Mitigation Plan  
Banner Branch Mitigation Project  
Stokes County, North Carolina  
FINAL VERSION

NCDEQ DMS Project Identification # 100080  
NCDEQ DMS Contract # 7610 and # 7701  
Roanoke River Basin (Cataloging Unit 03010103)  
USACE Action ID Number: SAW-2018-01760  
Contracted Under RFP # 16-007405  
DWR Project # 20181154

Re: NCIRT Review and USACE Approval of the NCDMS Banner Branch Mitigation Site /  
Stokes Co./ SAW-2018-01760/ NCDMS Project # 100080

**SUBJECT:** Banner Branch Mitigation Site - NCIRT Comments during 30-day Mitigation Plan Review

SHEET NUMBER  
**15**

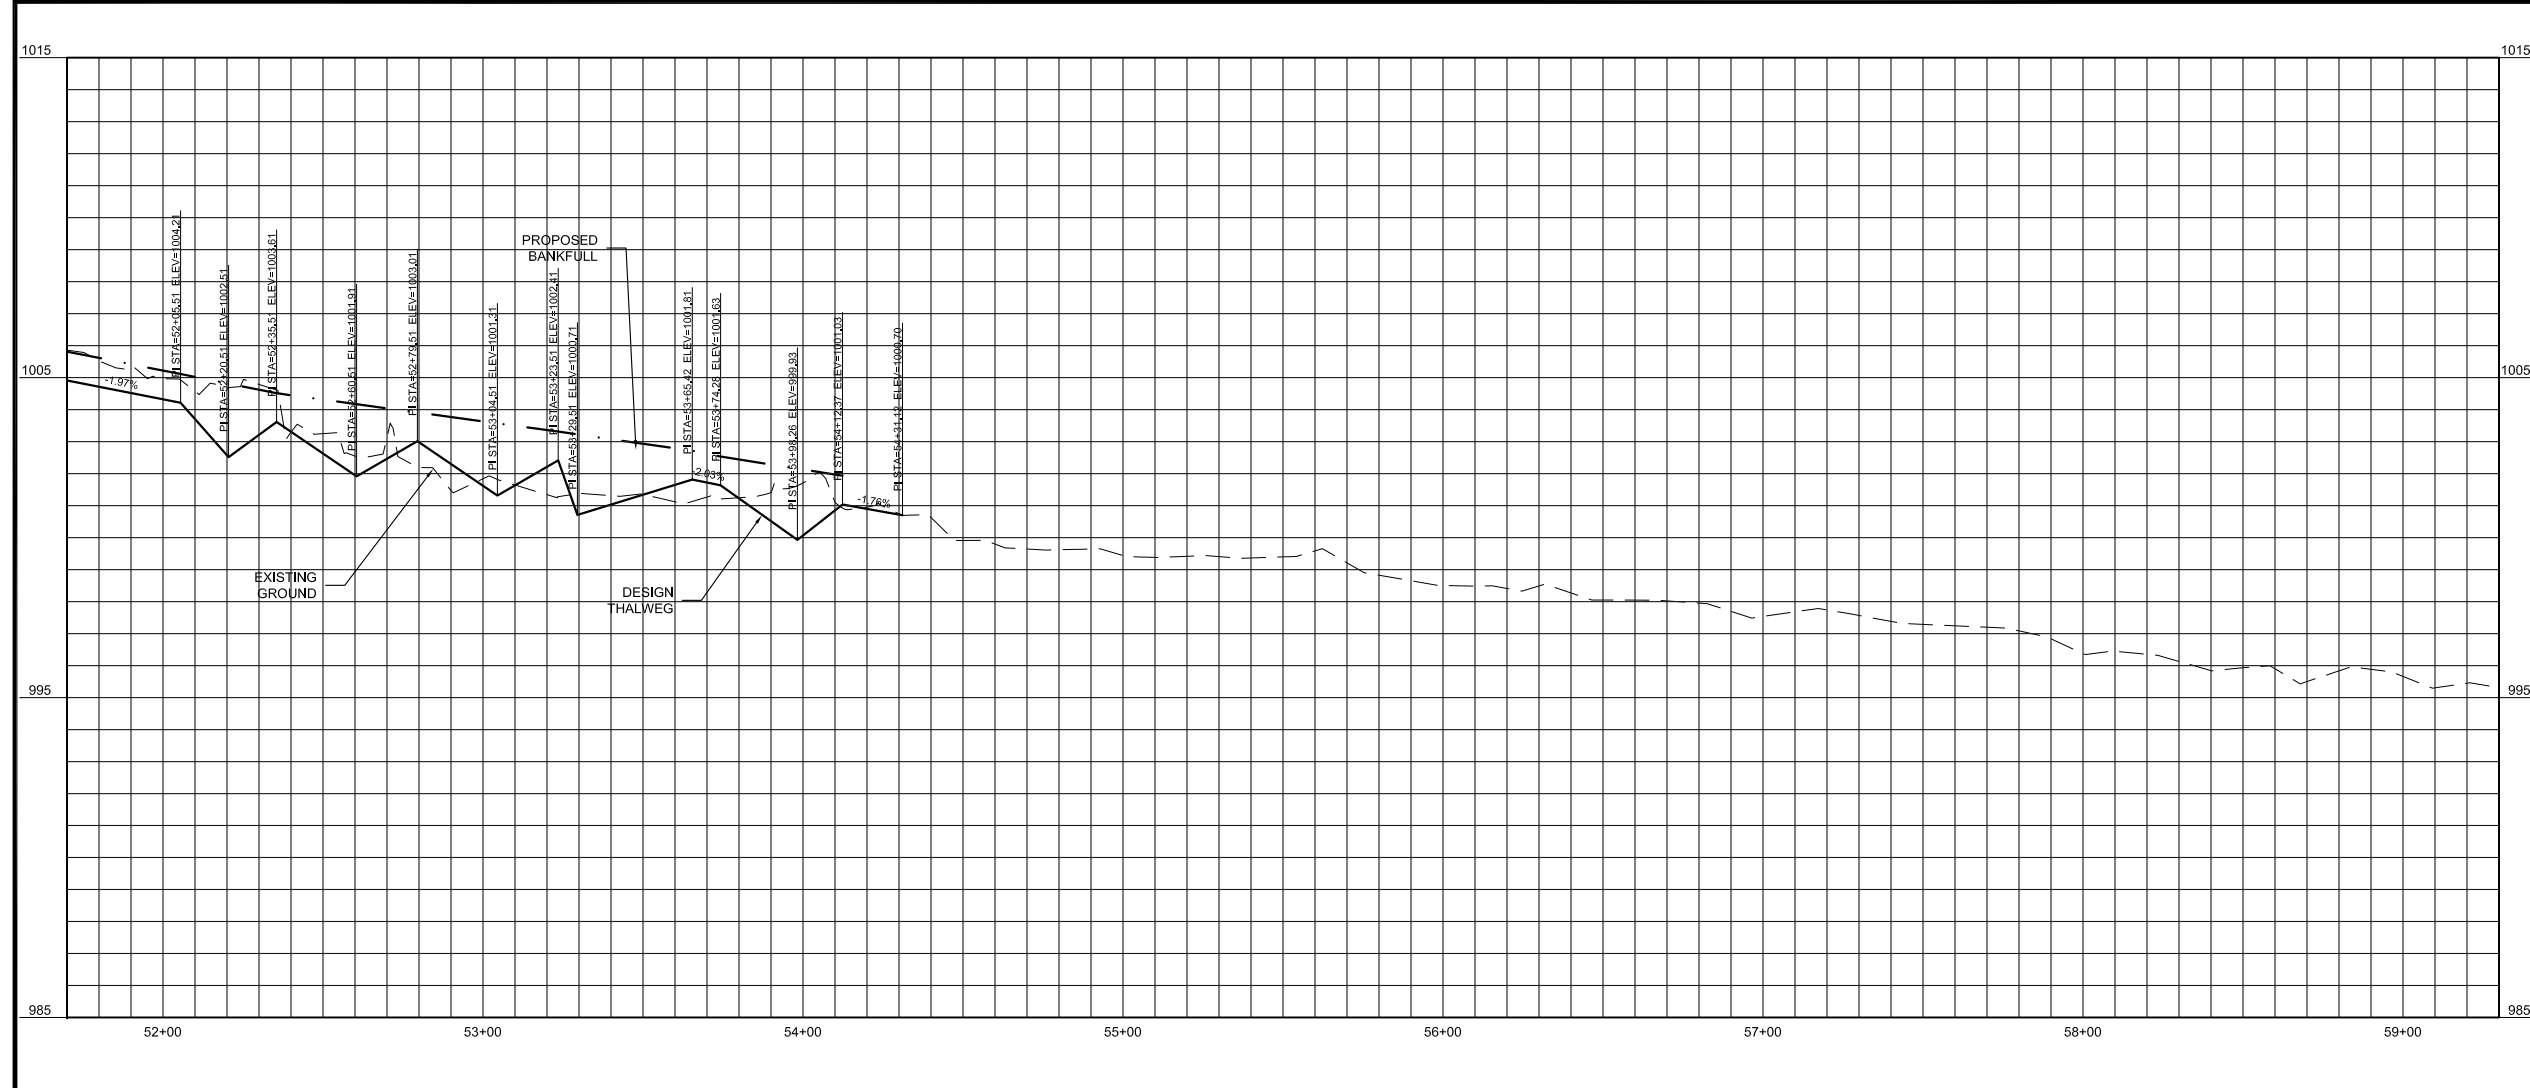
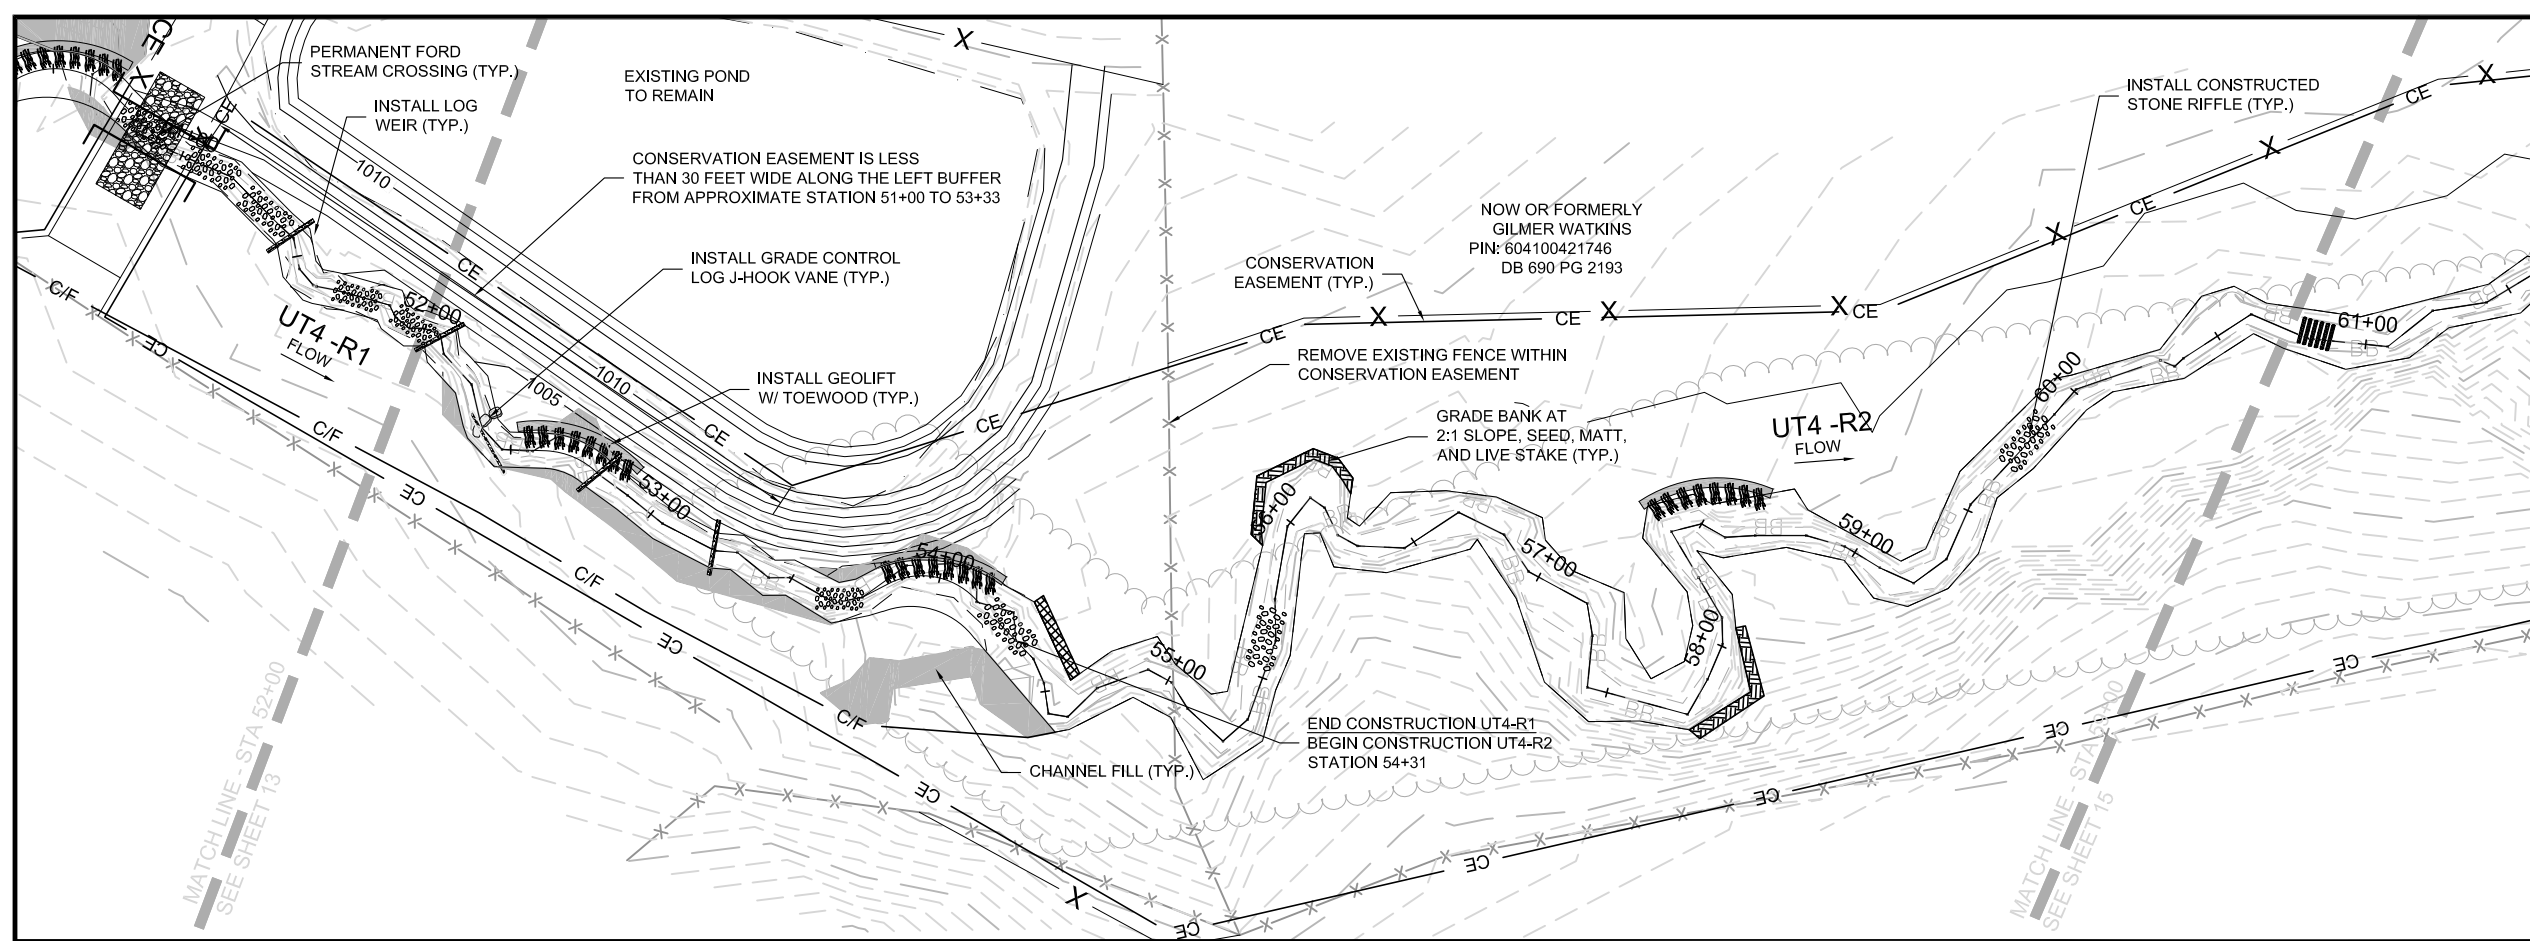
24. Sheet 13 – Please confirm the profile callouts for existing ground and design thalweg are indicating the correct features.
25. Sheet 15 – The CE crosses the southwest corner of the existing pond. Please show how this area will be graded within and immediately adjacent to the CE line.

**25. Sheet 15 - The CE crosses the southwest corner of the existing pond. Please show how this area will be graded within and immediately adjacent to the CE line.** Response: WLS has revised the pond grading so that the entire CE break is a flat crossing and does not include the pond or any part of the pond water surface.

**18**

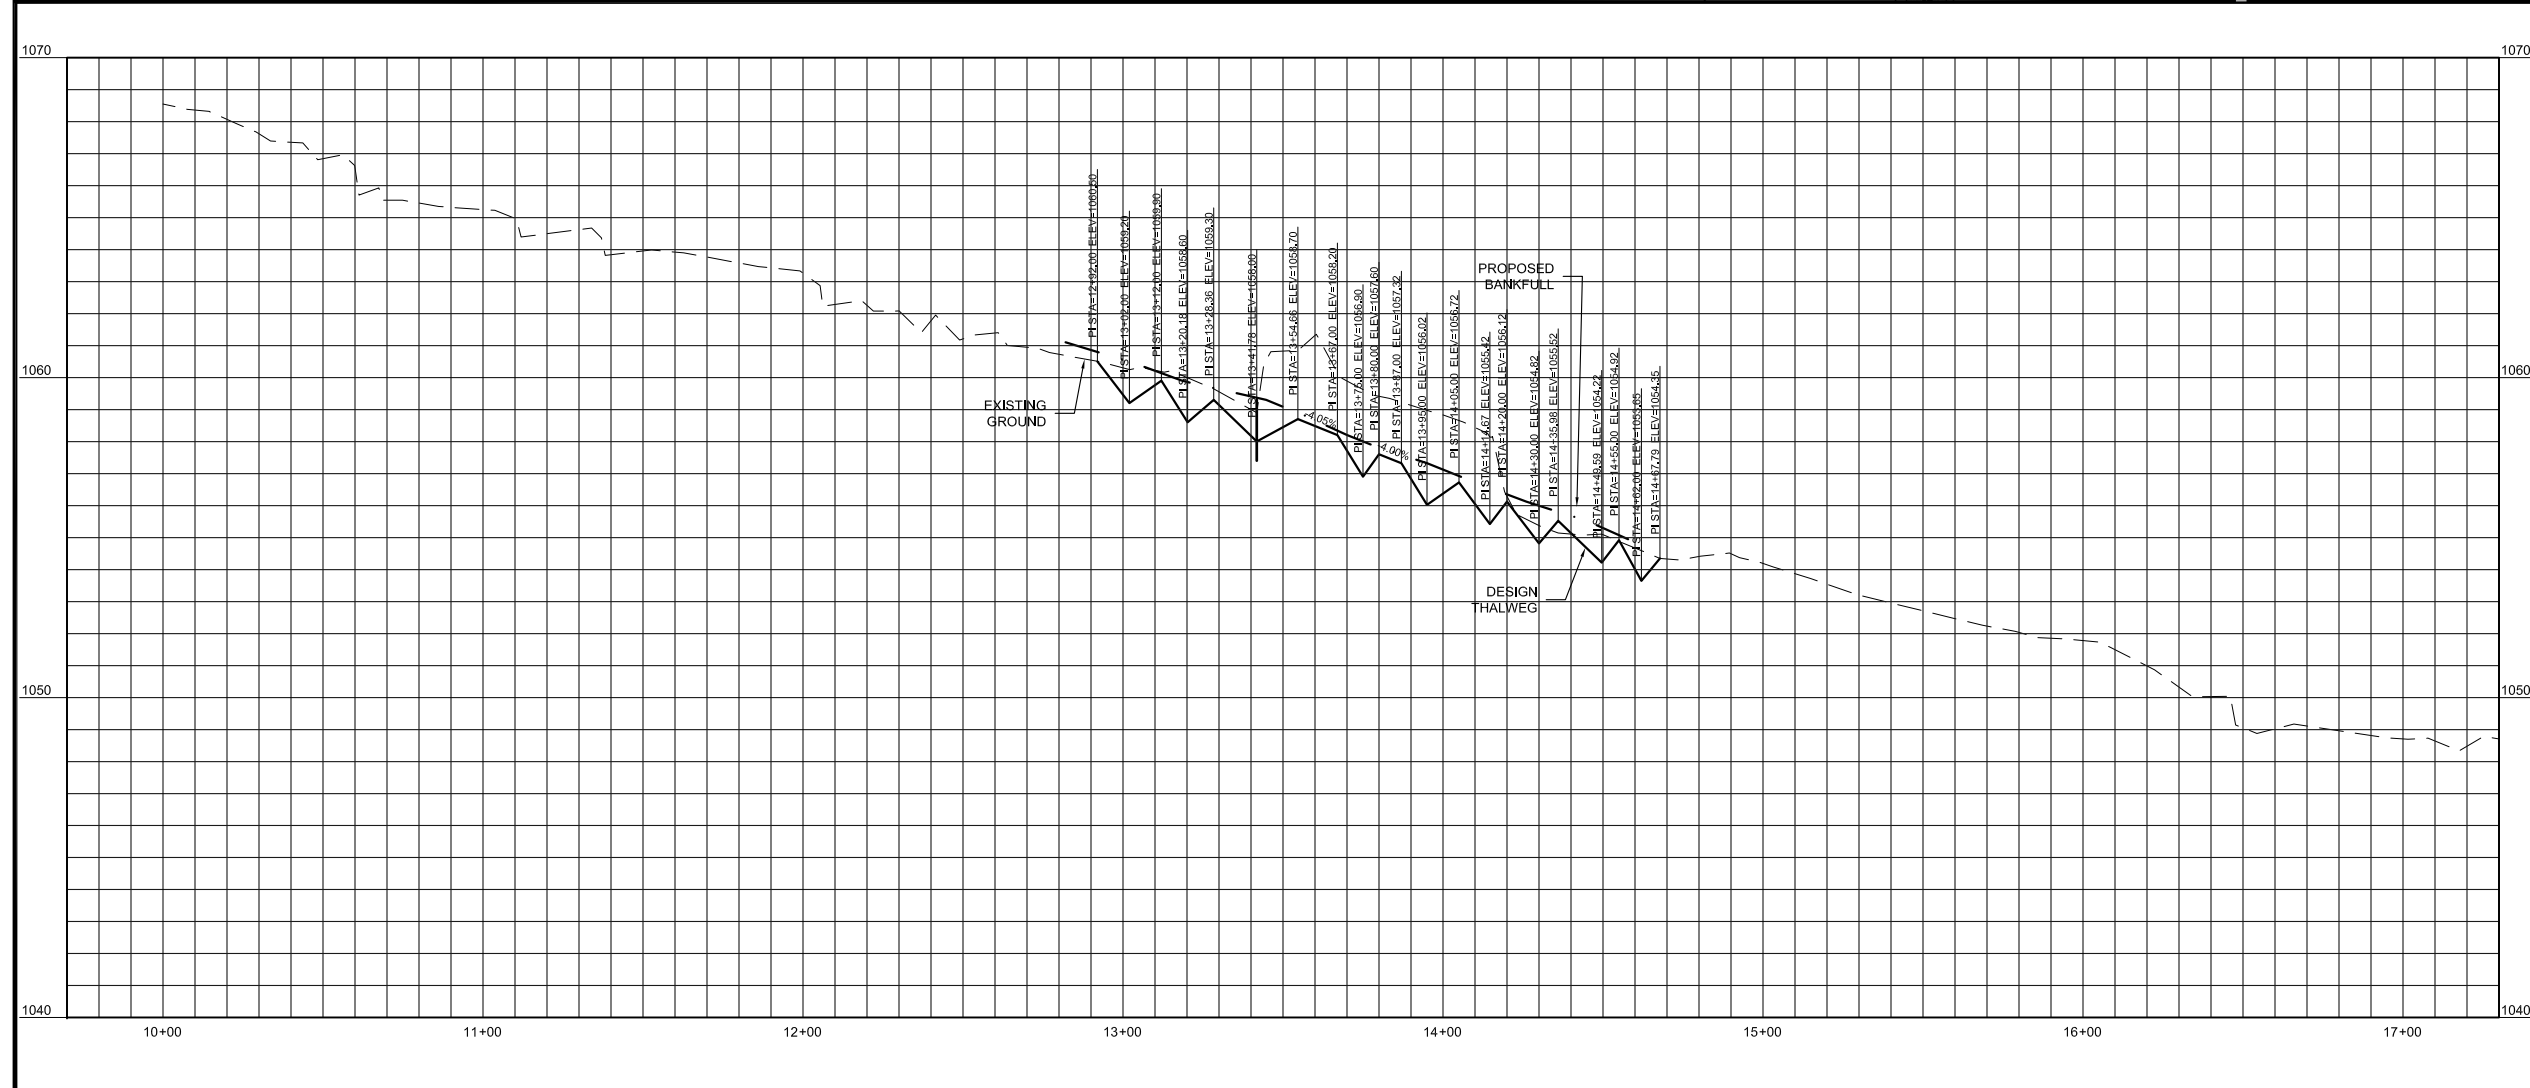
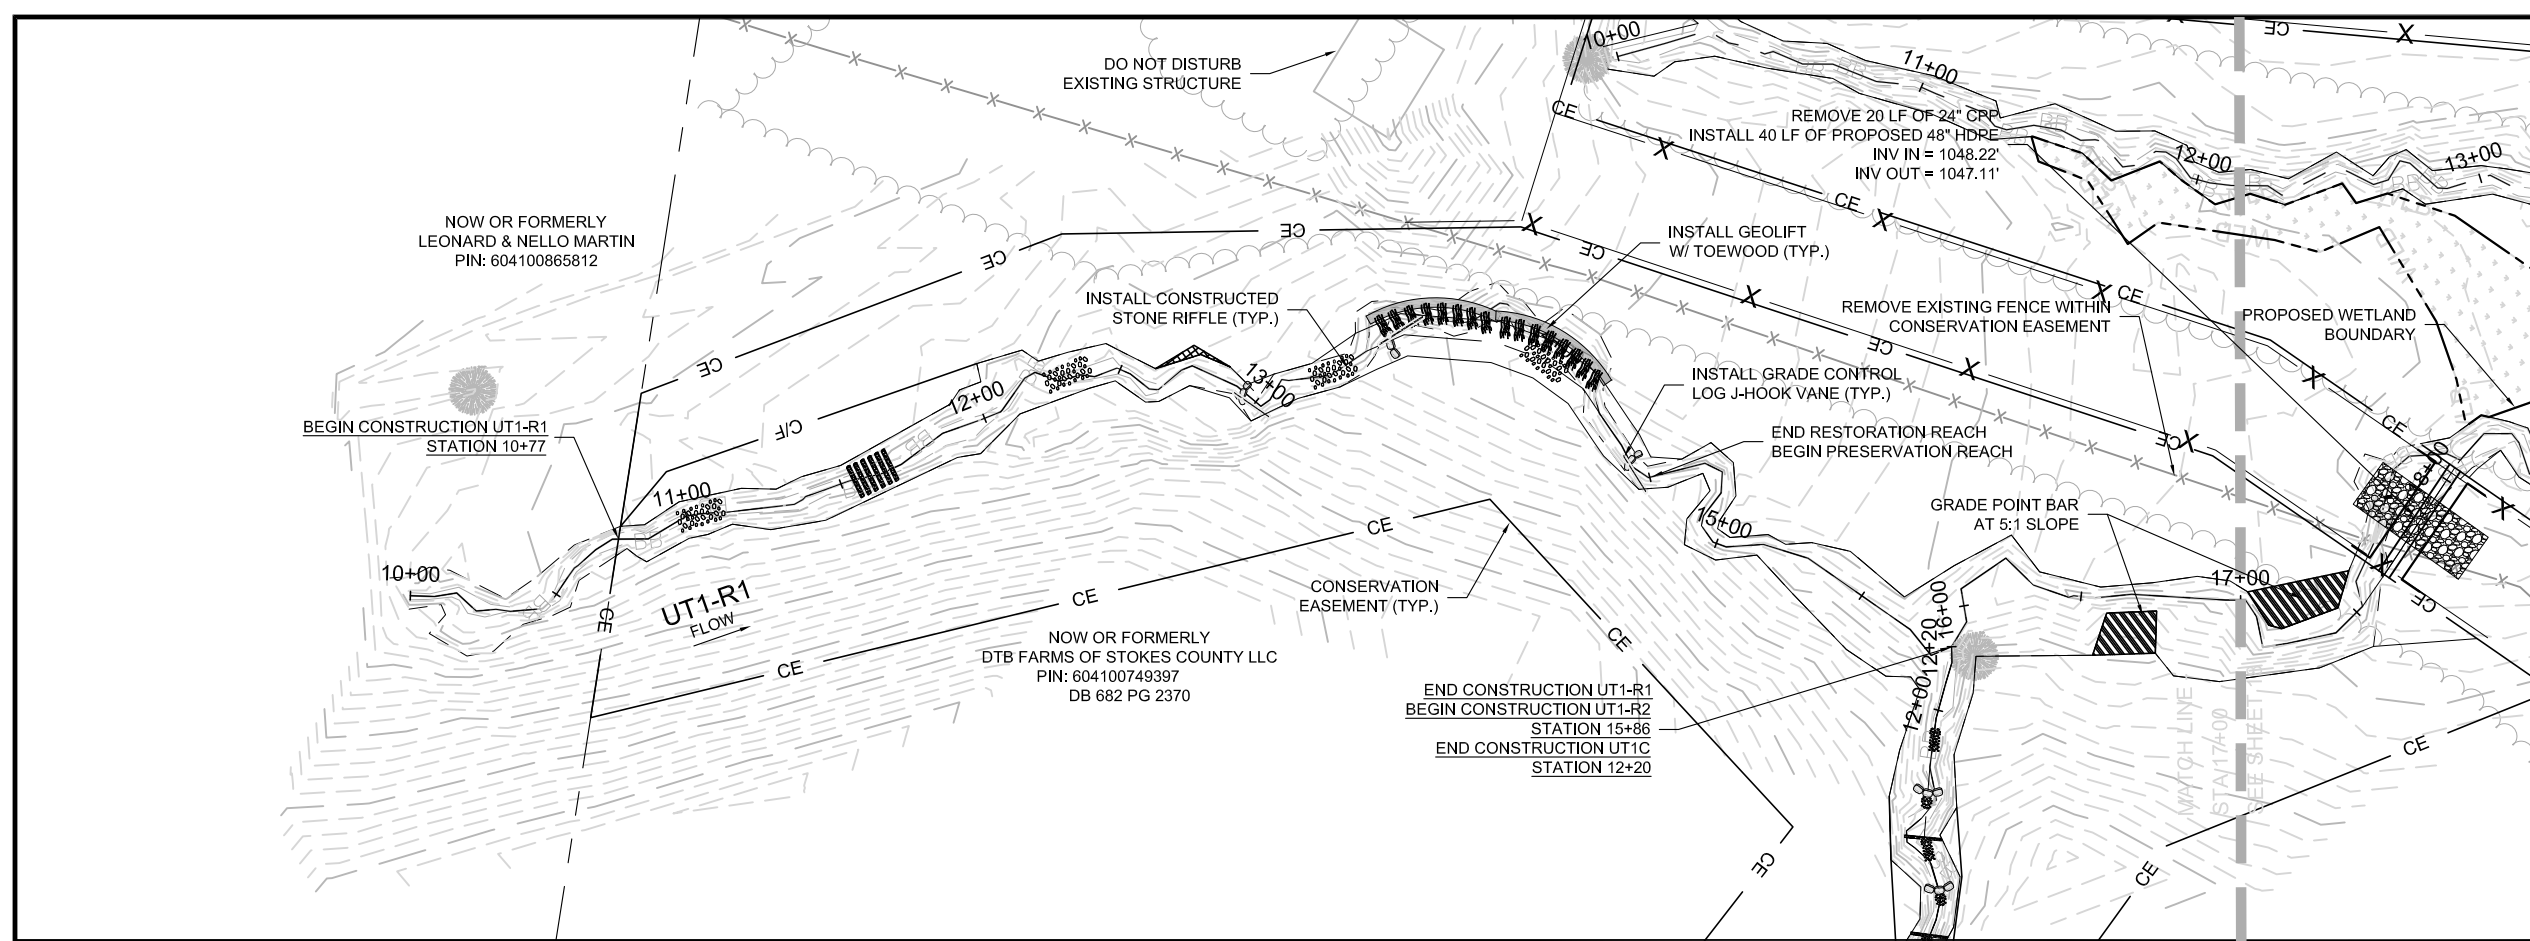
23. Sheet 18 – Based on the proposed work, UT1-R1 appears to align more as an Enhancement I approach compared to Restoration, where the full length of stream will have dimension, pattern and profile improvements. Additionally, only partial buffer planting is proposed. Further justification is needed for DWR to support this reach for restoration credit.

**23. Sheet 18 – Based on the proposed work, UT1-R1 appears to align more as an Enhancement I approach compared to Restoration, where the full length of stream will have dimension, pattern and profile improvements. Additionally, only partial buffer planting is proposed. Further justification is needed for DWR to support this reach for restoration credit.** Response: WLS has revised the approach along UT1-R1 to Enhancement Level I with a 1.5:1 credit ratio. The original concept approach was to relocate and re-establish the incised channel away from the right toe of slope. We have updated Table 1, Table 14, and Section 6.1.2, pg 47 accordingly.
